Campbell River Environmental Committee
2353 Dolly Varden Road
Campbell River, BC
V9W 4W5

Re: **Review of GHD Technical Responses Task 7 and Task 8 - Upland Landfill – Waste Discharge Application Tracking Number 335965 and Authorization Number 107689 7295 Gold River Highway, Campbell River, British Columbia**

1 REVIEW OF GHD SAND AND GRAVEL AQUIFER PUMPING TESTS DOCUMENT

2 REVIEW OF GHD ADDITIONAL BEDROCK CHARACTERIZATION REPORT

Figure 1: Data logger information - Potential misinterpretation (modified from GHD Figure 4.4)

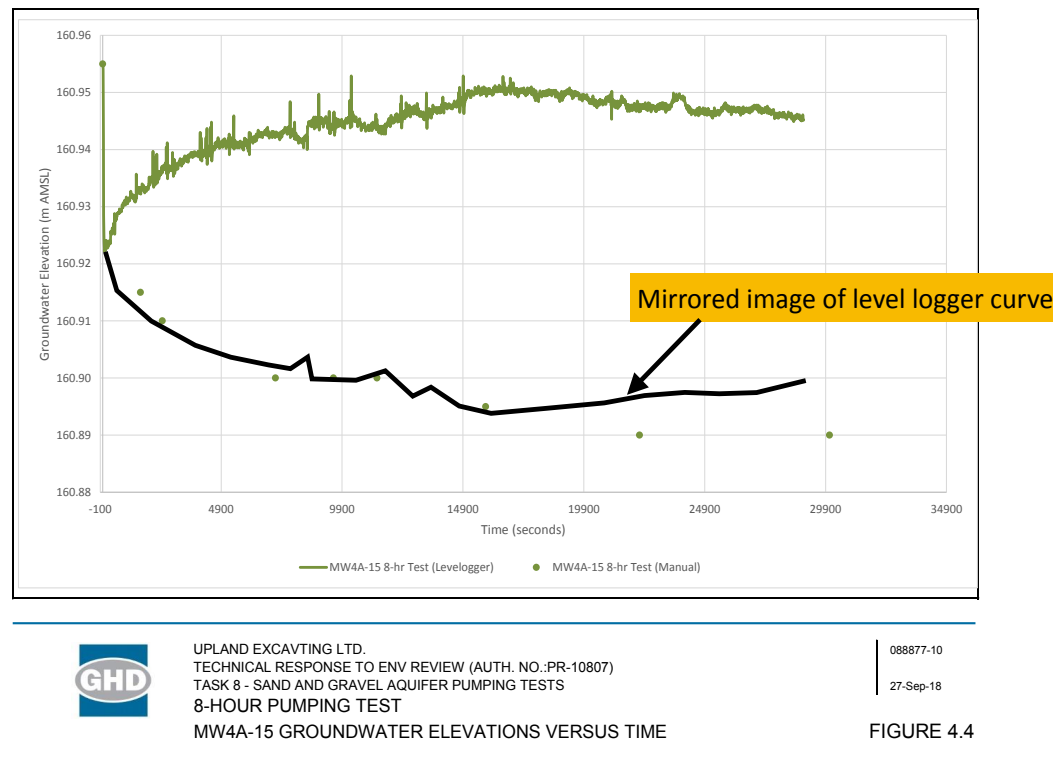
GW Solutions disagrees with this interpretation. It appears that GHD has made a mistake in the processing of the data from the datalogger.

GW Solutions has noticed that the data logger curve seems to mirror the manual data (Figure 1). Therefore, it is unlikely that such a curve could simply be interpreted by a drift of the data logger. GHD analysis should be reviewed and corrected, should GW Solutions assumption be correct.

Figure 2: Bedrock topography and trough (estimated location) (Source: GHD Figure 7.1A modified)

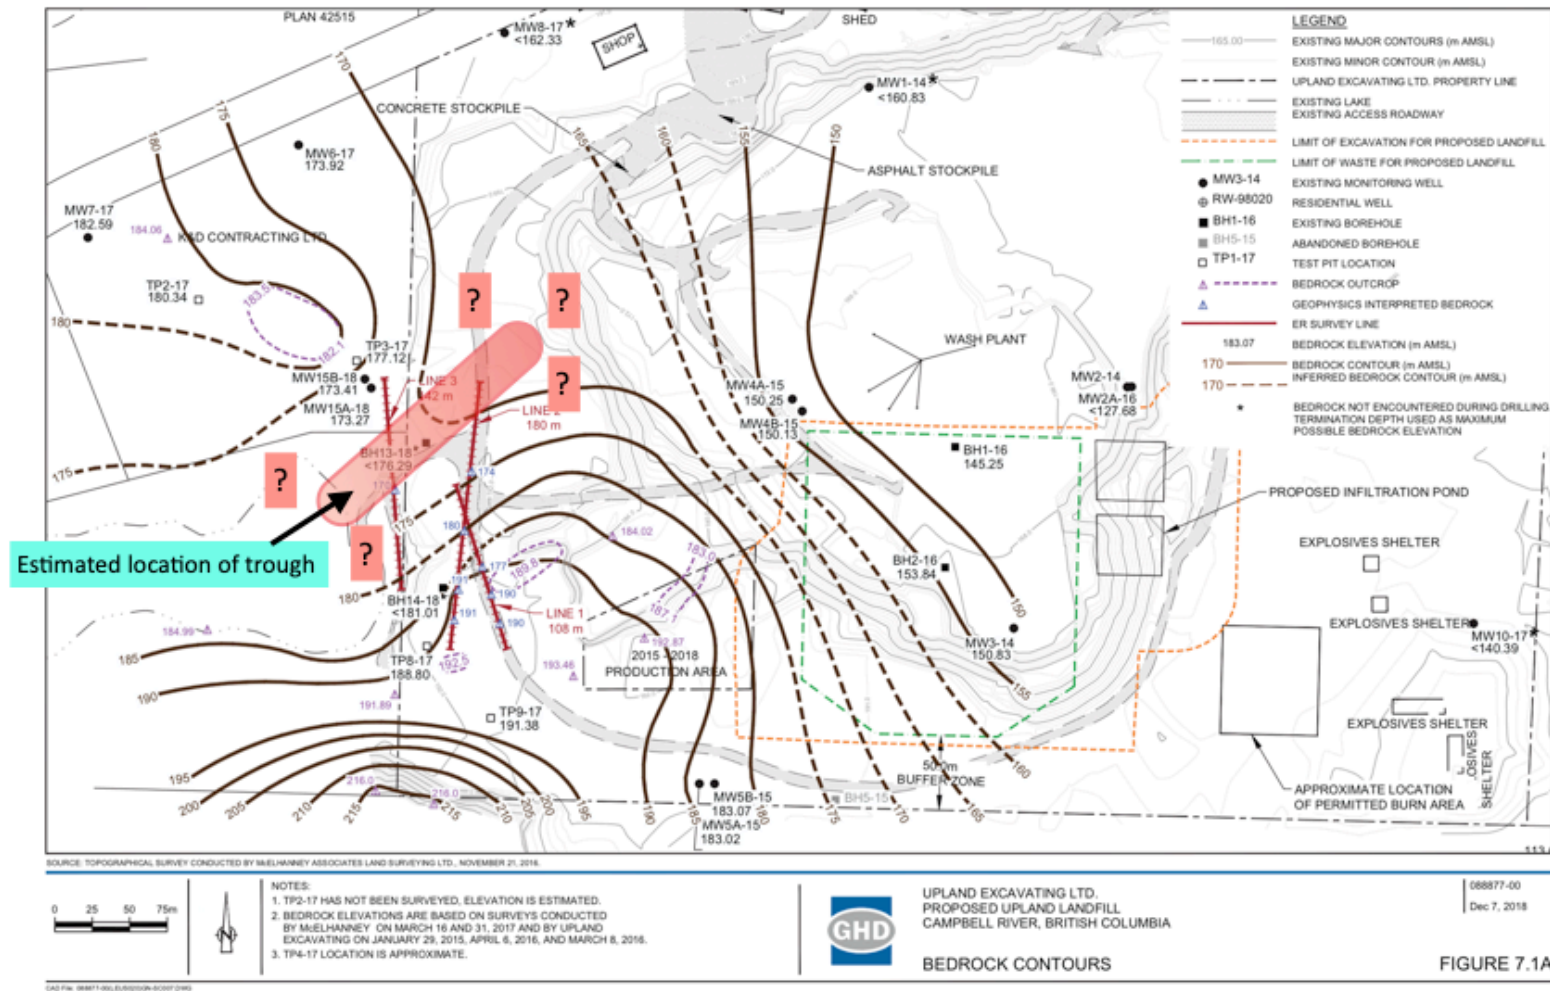
- *Bedrock elevations between Rico Lake and the Pit were initially interpreted to range in elevations from 180 to 192 m AMSL. Based on new data collected, bedrock elevations between Rico Lake and the Pit are now observed to range between 170 to 193.46 m AMSL. A sand and gravel filled trough or scour channel in the bedrock surface appears to extend northeast from Rico Lake.*

GW Solutions globally agrees with this comment. This confirms a hydraulic connection between Rico Lake and the pit.

The size and type of infill of these saddles/trough/crevices need to be characterized, as they will act as a conduit between Rico Lake and the landfill. This is critical new information which indicates a direct hydraulic connection between Rico Lake and the Upland Landfill.

Figure 3: Water table in sand and gravel aquifer (Source: GHD Figure 5.1 – Oct 2018)

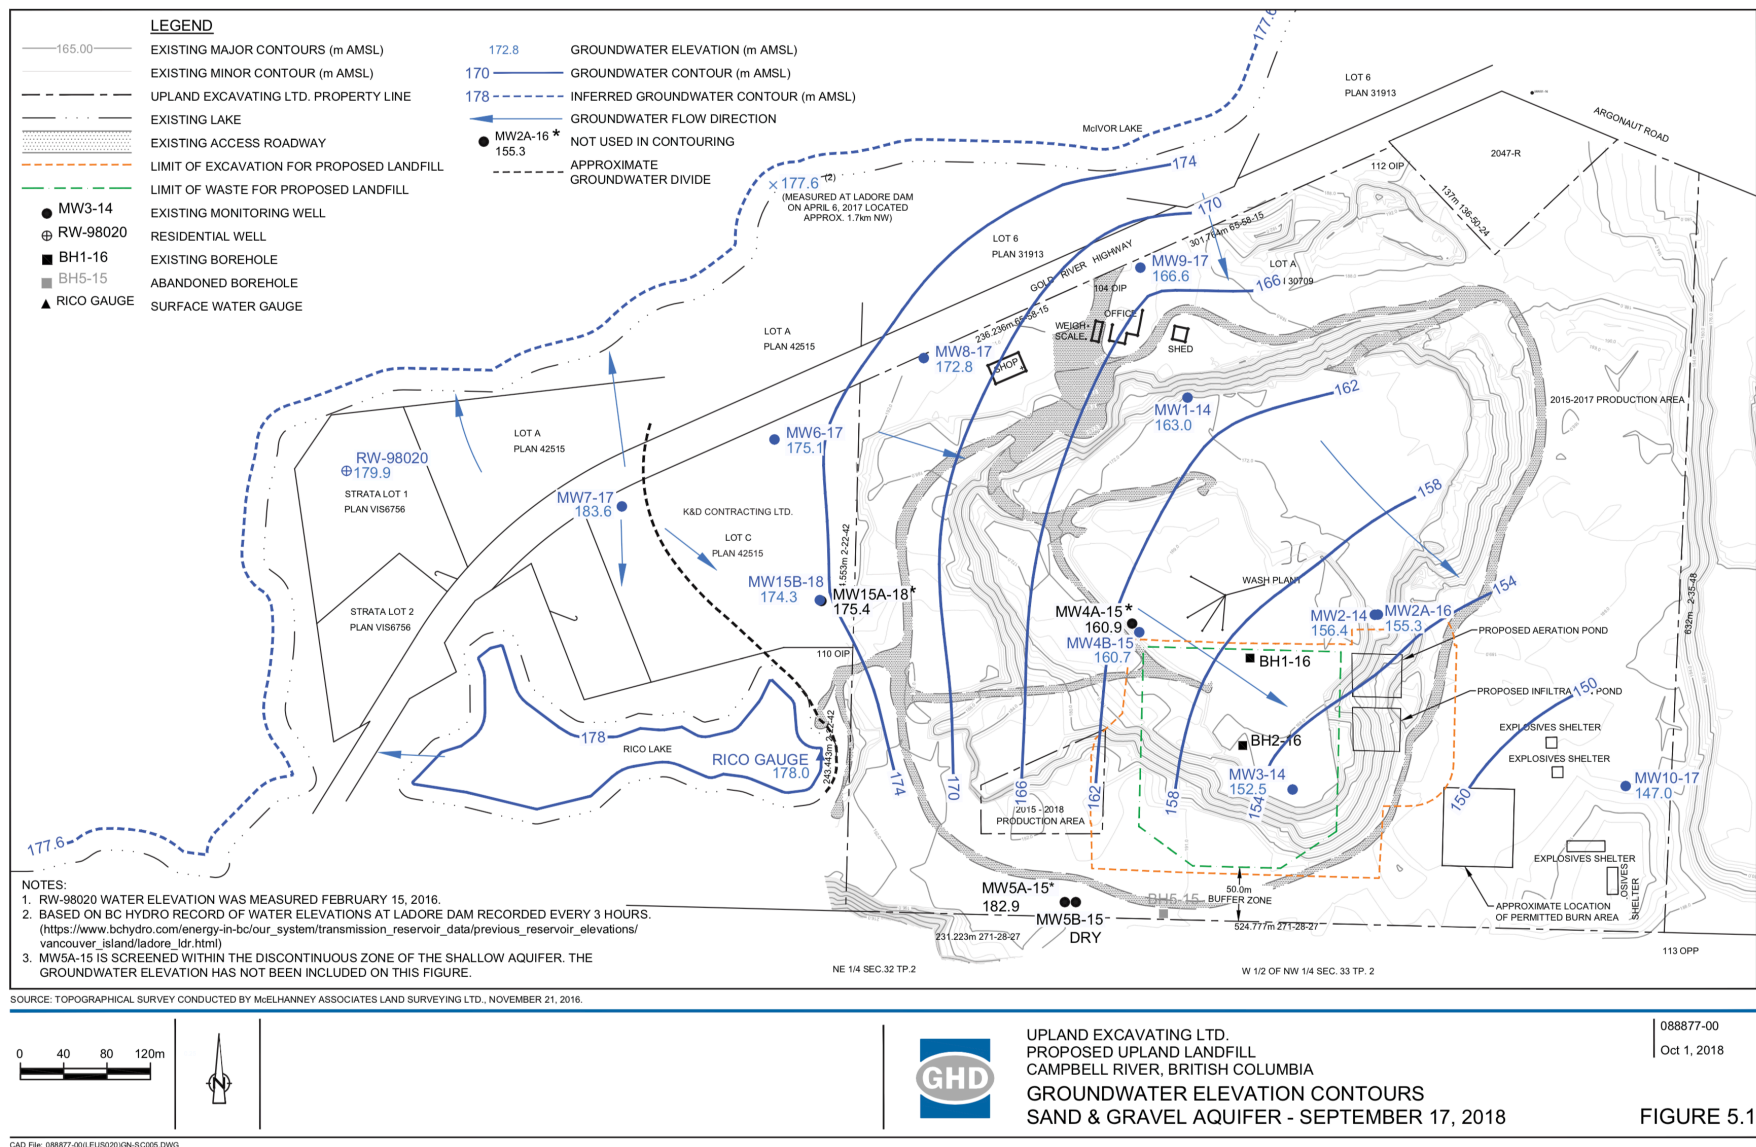
According to GHD, the elevation of the pit floor is approximately between 168 m and 169 m (Figure 3), and the elevation of the water table is expected approximately between 154 m and 162 m (Figure 3). Therefore, the water table should be at least 6 m below ground.

According to GHD, the sand and gravel is thick under the pit (Figure 4), and its hydraulic conductivity 2×10^{-2} cm/s (Technical Response to ENV Review (Auth. No.:Pr-10807) Task 8). **With such a high hydraulic conductivity, water should not be ponding, and surface water is expected to infiltrate very rapidly through the pit floor.**

Figure 4: Cross-section through site (Source GHD Figure 2.11, October 30, 2018)

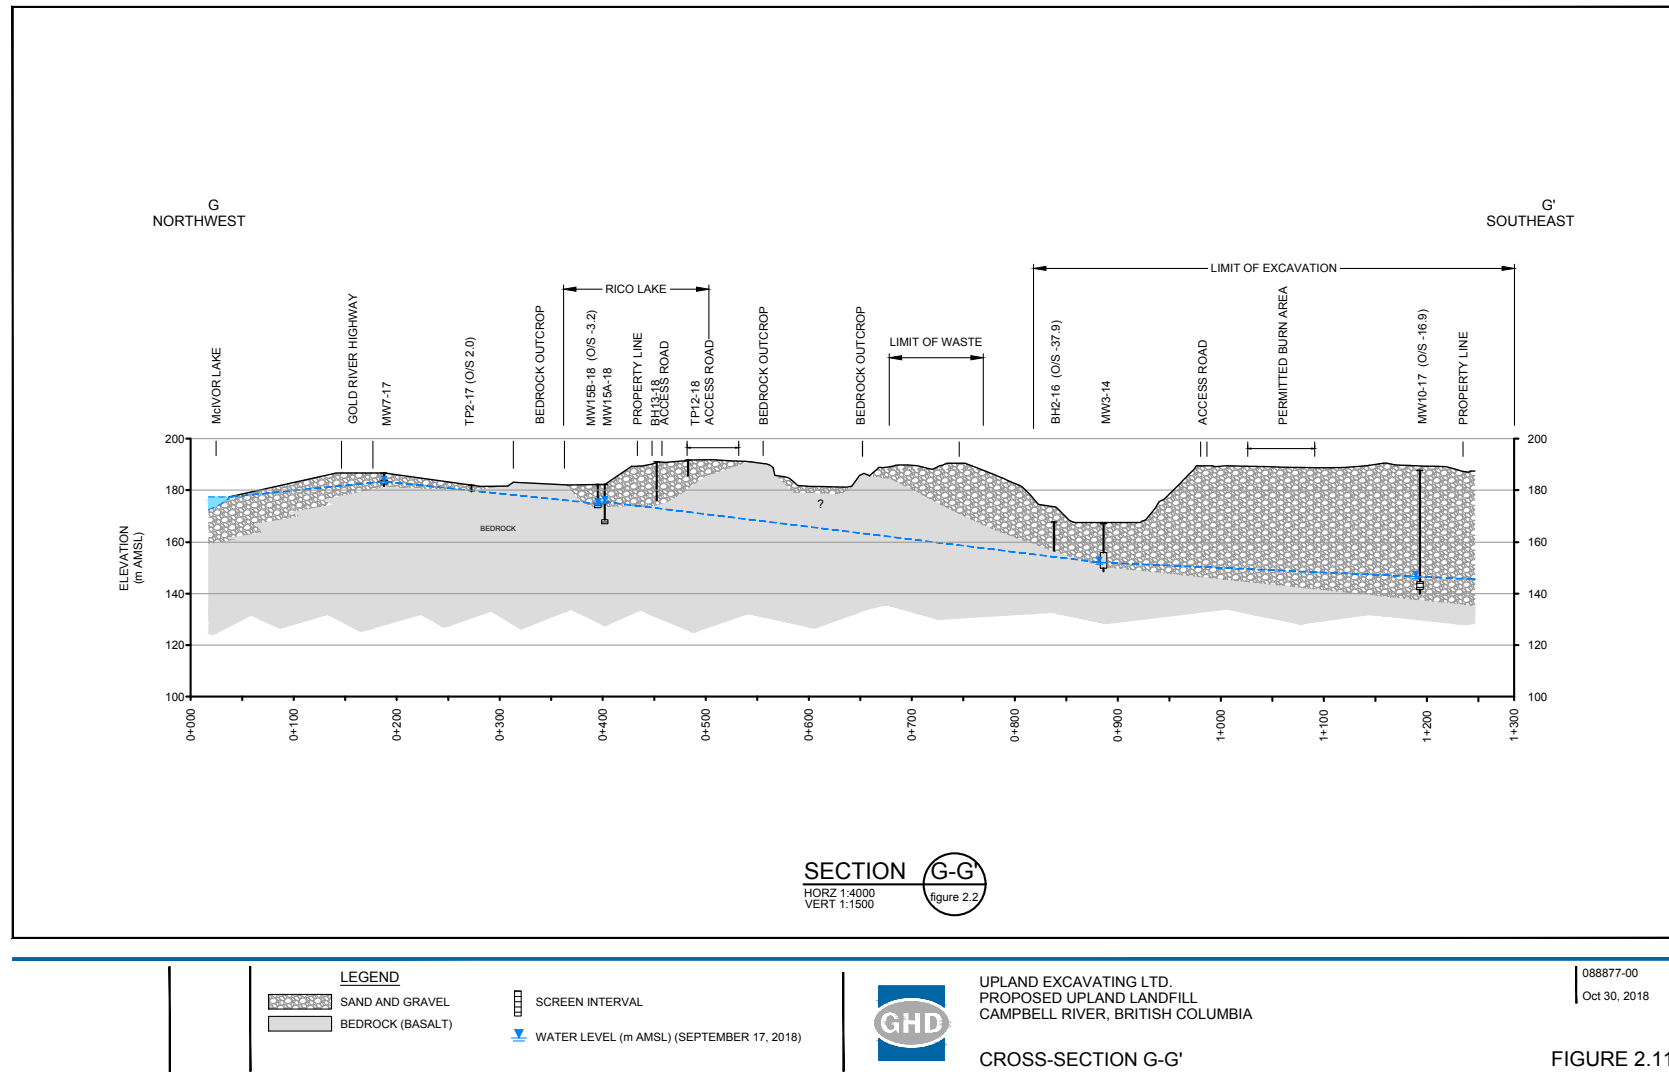
The location of both the limit of excavation and limit of waste footprints are misplaced.

Figure 5: East-West cross-section showing two aquifers (Modified from EBA 2004, Figure 6)

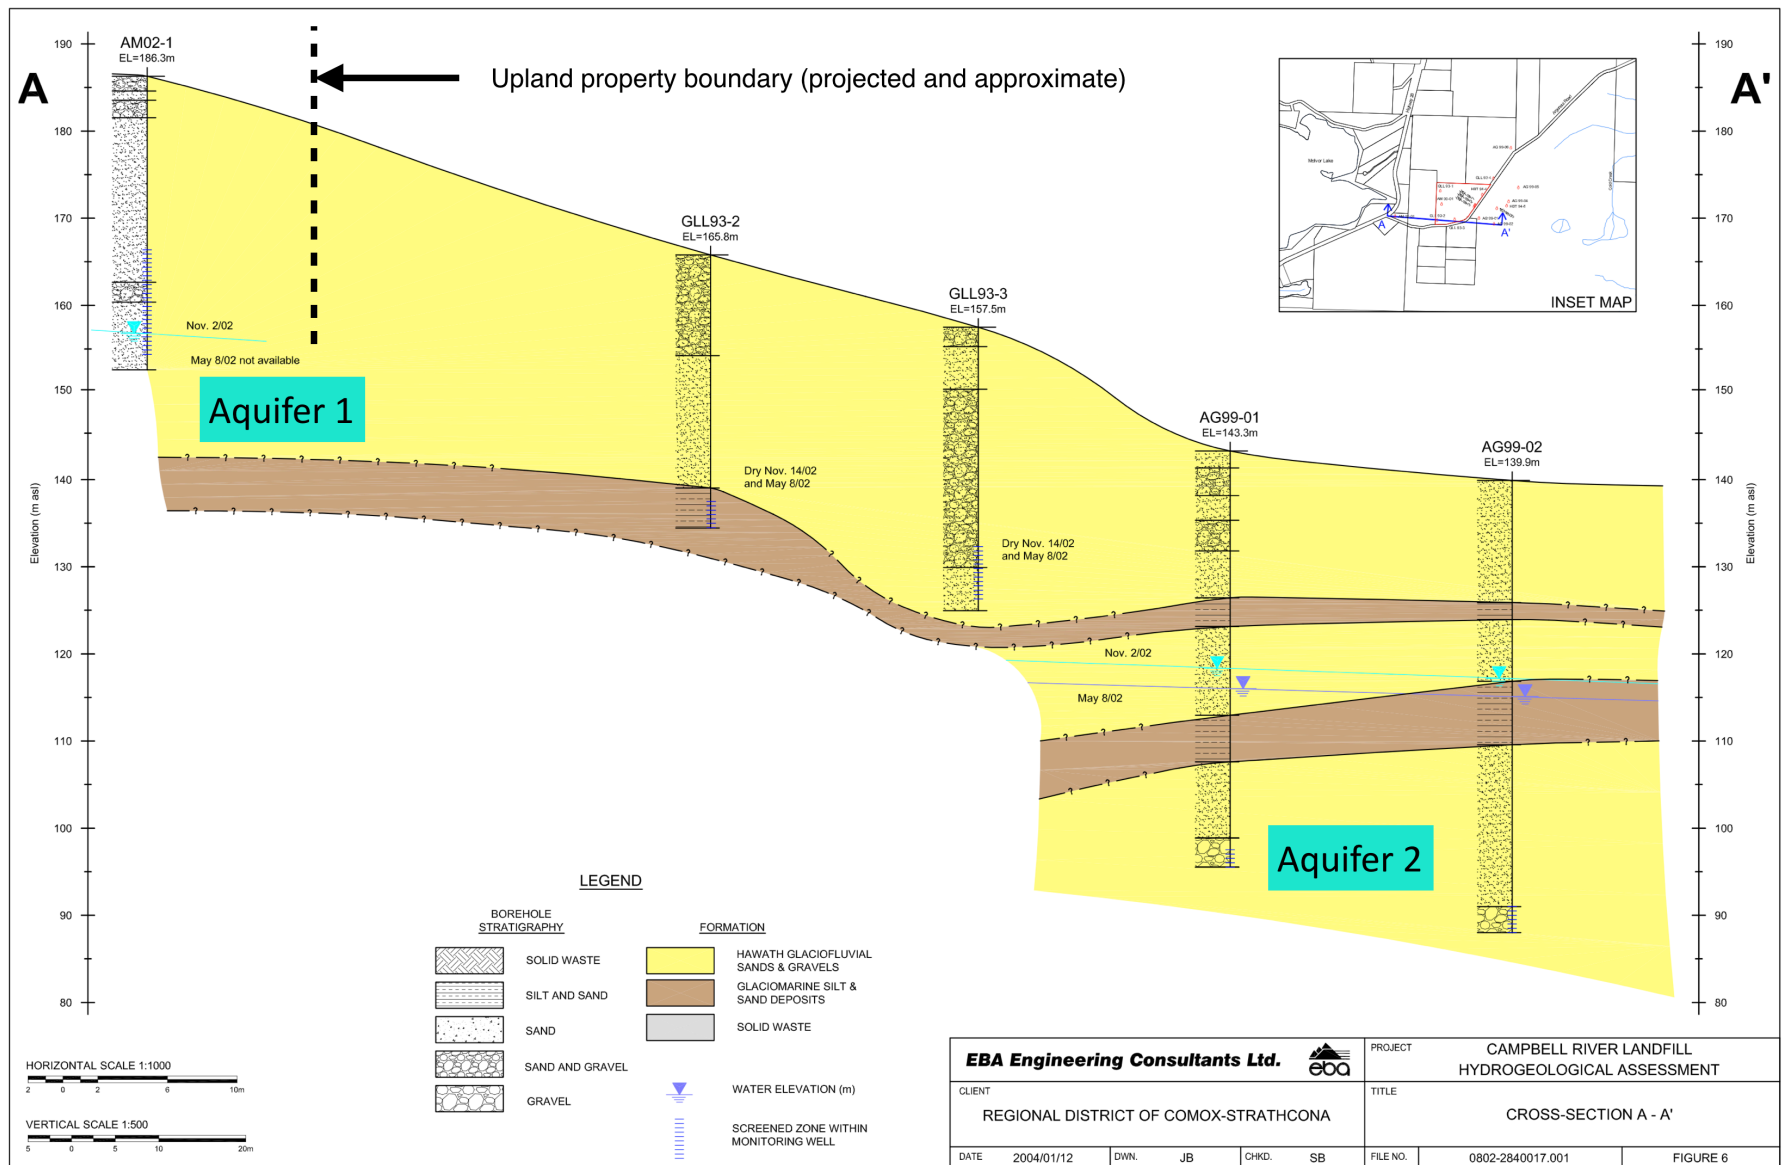
In its *Campbell River Landfill Hydrogeological Assessment* (2004), EBA has produced a cross-section showing the presence of two aquifers in the sand and gravel deposits along Argonaut Road (Figure 5). These two aquifers, identified as Aquifer 1 and Aquifer 2 in Figure 5, are due to layers of sand deposits containing silt and acting as aquitards (shown in brown in Figure 5). **We note that Aquifer 1 is present at the right of the eastern boundary of Upland property.** Therefore, it is possible that the ponded water observed at the pit floor is daylighting groundwater from Aquifer 1, and that the presence of two aquifers in the sand and gravel deposit under the Upland property has been overlooked during GHD hydrogeological characterisation of the Upland property, in part due to the absence of monitoring wells in the northeast quadrant of the Upland property.

If the presence of two aquifers is confirmed under Upland property, this should be considered to a) assess whether Upland is meeting existing mining regulations in regard to protection of aquifers and b) assess how the presence of a shallow aquifer modifies the waste discharge application under review.
